Re: El Paso Natural Gas Company, L.L.C.;
Docket No. CP20-483-000
Responses to Data Request - OEP/DG2E/Gas Branch 3

EL PASO NATURAL GAS COMPANY, L.L.C.
Response to Data Request - OEP/DG2E/Gas Branch 3
Dated September 3, 2020 in Docket No. CP20-483-000
Carlsbad South Project

Figure 1 – Karst Survey Track lines.

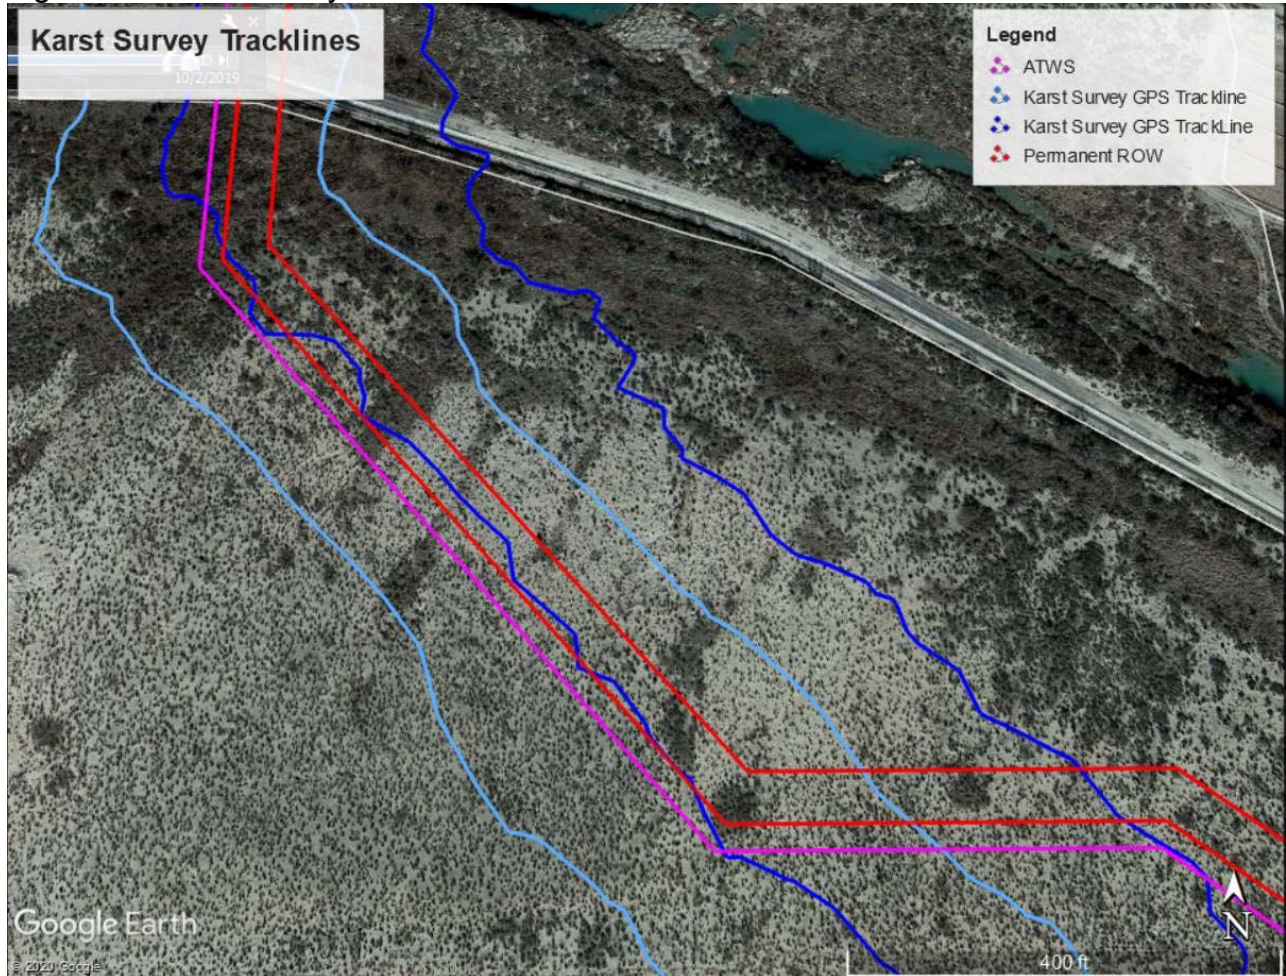
1. Confirm that El Paso's initial karst survey covered the area requested for the pipeline realignment variation filed August 28, 2020. Identify any karst features along the newly proposed route realignment in Eddy County, New Mexico. If karst features exist in this area, describe any such features, and explain how the pipeline could be installed taking such features into consideration.

El Paso Natural Gas Company, L.L.C. ("El Paso") conducted its initial karst survey from September 30, 2019, to October 2, 2019. The survey included the original right-of-way and extended 100 meters (equal to approximately 328 feet) on each side of the right-of-way. Figure 1 below is an aerial view of the project area showing the proposed reroute and the karst survey track lines collected via GPS when the survey was conducted. No karst features were identified in either the original right-of-way or the proposed reroute.
